CH-VDEX

SOLID RETAINER SERIES: OVAL AND ROUND COLLAR FOR FOUR-BOLT OR GOOSENECK CHIPPING HAMMERS

ENGINEERING BULLETIN

Effective 03-01-2018

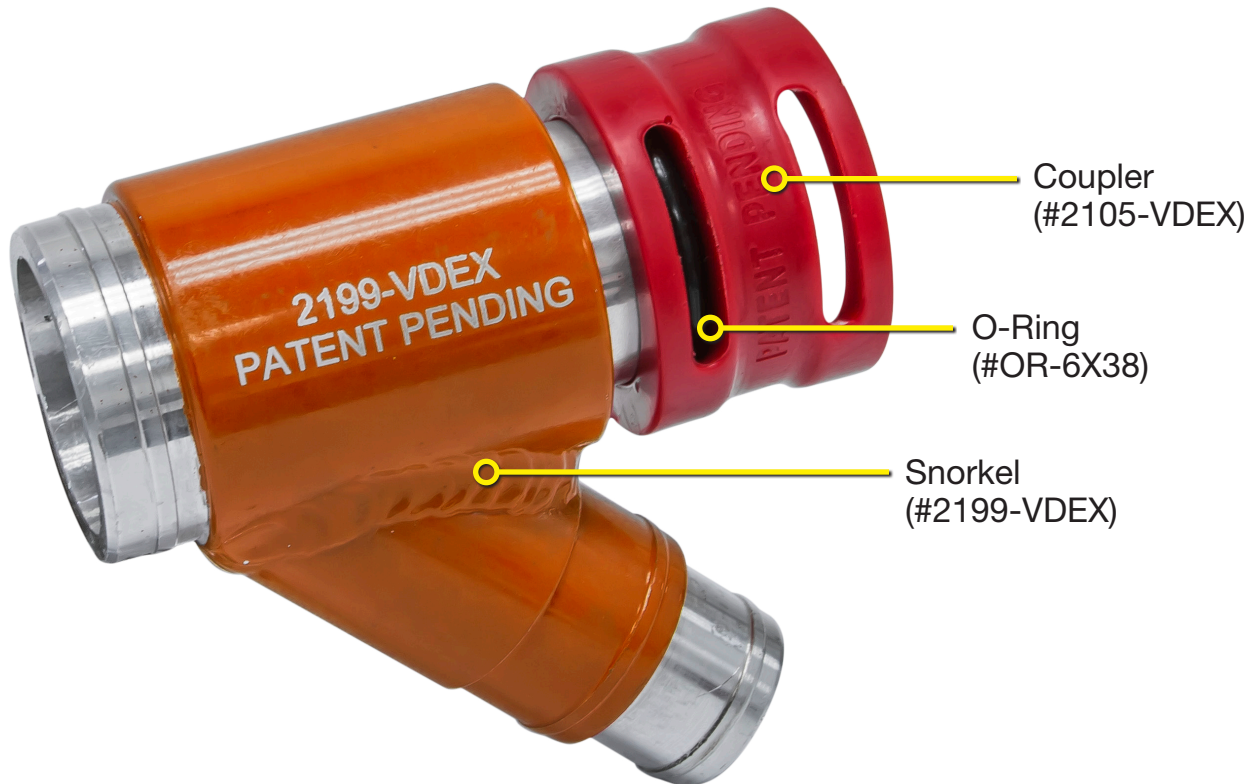
In an effort to bring you the best easy-to-use products we have taken the liberty of connecting the Coupler (#2105-VDEX) onto your VDEX Snorkel attachment (#2199-VDEX) with the O-Ring (#OR-6X38). There should be no need to dismantle this sub-assembly, but should you need to, you can replace the O-Ring with a Retainer Spring (#1194-2).
